Township of Lawrence
ENGINEERING DEPARTMENT

SUBJECT: Preliminary & Final Major Site Plan Application No. SP- 3/24
Lawrenceville Development Group, LLC, 3131 Princeton Pike
Tax Map Page 38, Block 3801, Lots 2 & 3

DATE: September 5, 2024

Re: Lawrenceville Development Group, LLC
Preliminary and Final Major Site Plan
Block 3801 Lots 2 & 3
3131 Princeton Pike
3131 Princeton Pike Redevelopment Area

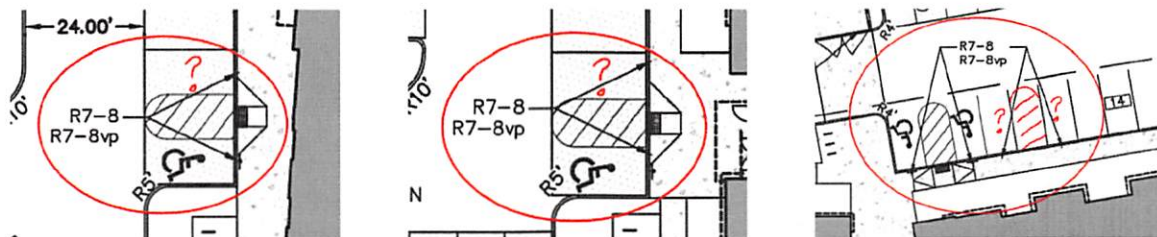
11. The submitted site plan (Sheet C3.01) shows 10 ADA spaces, while the Traffic Study states 12 ADA spaces, which should be addressed. Moreover, four (4) of those 10 ADA spaces and accessible aisle striping were not marked properly (shown below), which must be addressed.

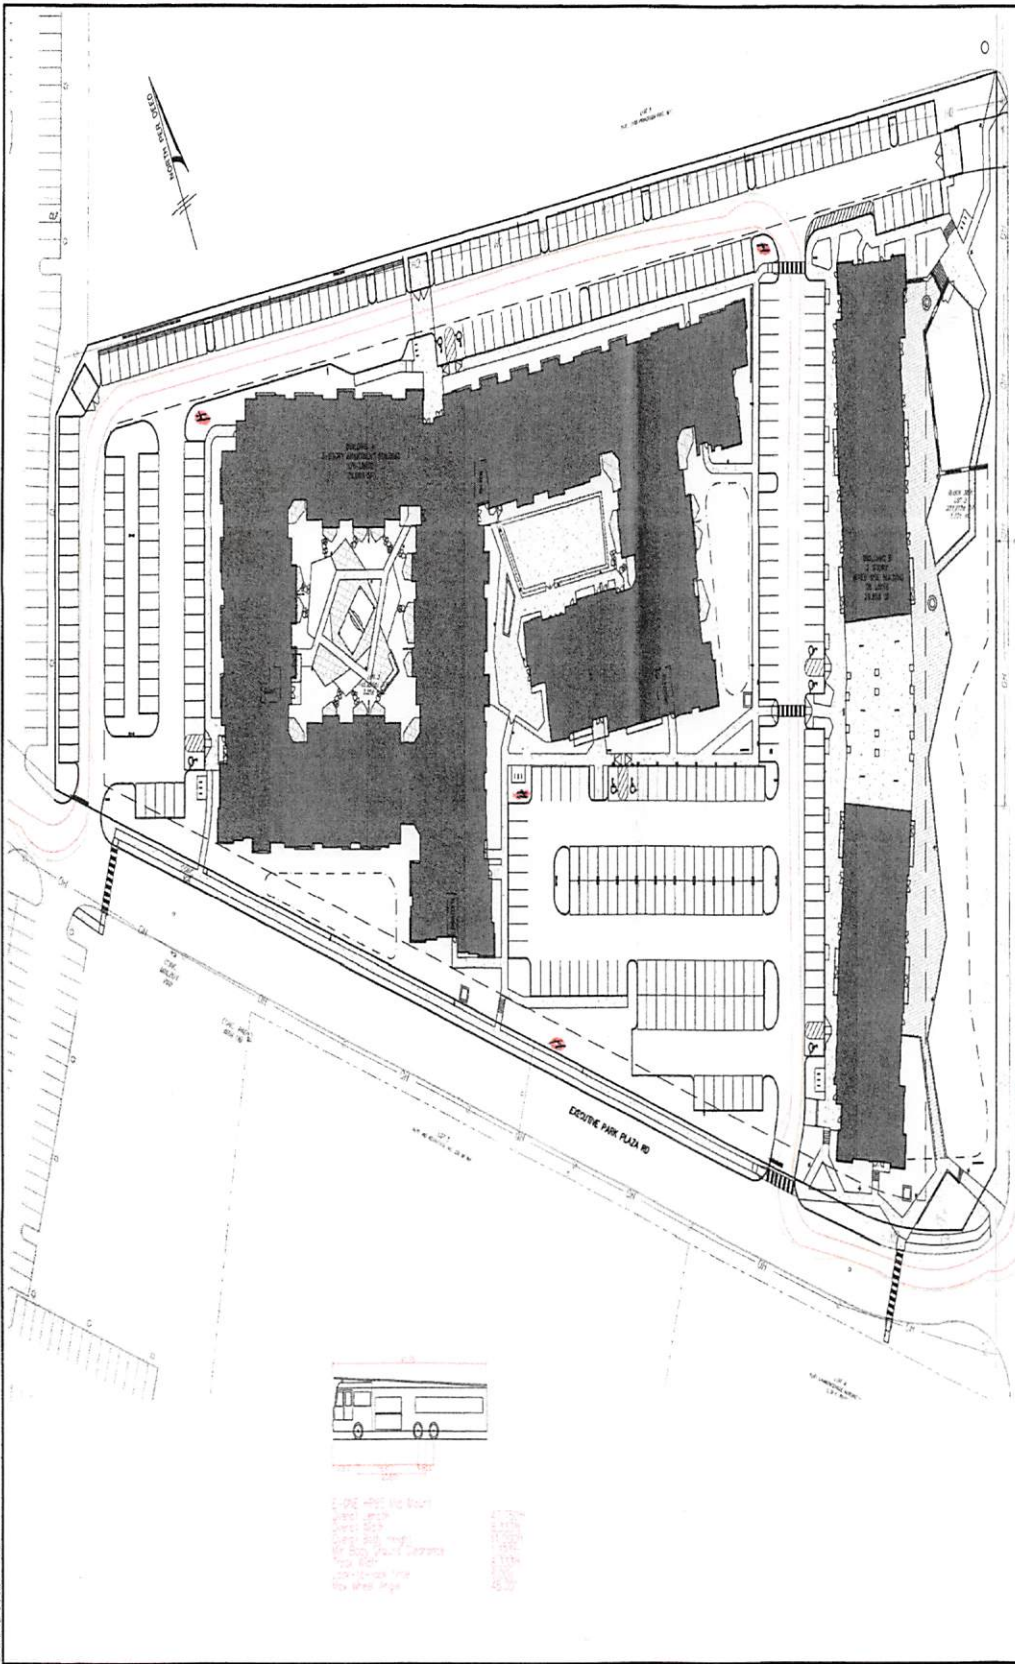
1. Location of proposed fire hydrants to be installed on property, unable to determine the location on provided site plan. Recommendation to install additional fire hydrant, as indicated on provided drawing.

3. Fire Lane Markings with yellow paint and proper "NO PARKING FIRE LANE" signs to be installed in areas indicated in highlighter on provided drawing.
4. Provide proper designated areas for delivery vehicles for Buildings A & B, to prevent these deliver vehicles utilizing Fire Lanes or double parking in roadways prevent proper vehicular access.

5. Provide drawing for Fire Truck access, the largest Tower Ladder in operation is a 1993 100 foot rear mount ladder, with a 256" wheelbase and a 25 degree turning radius.
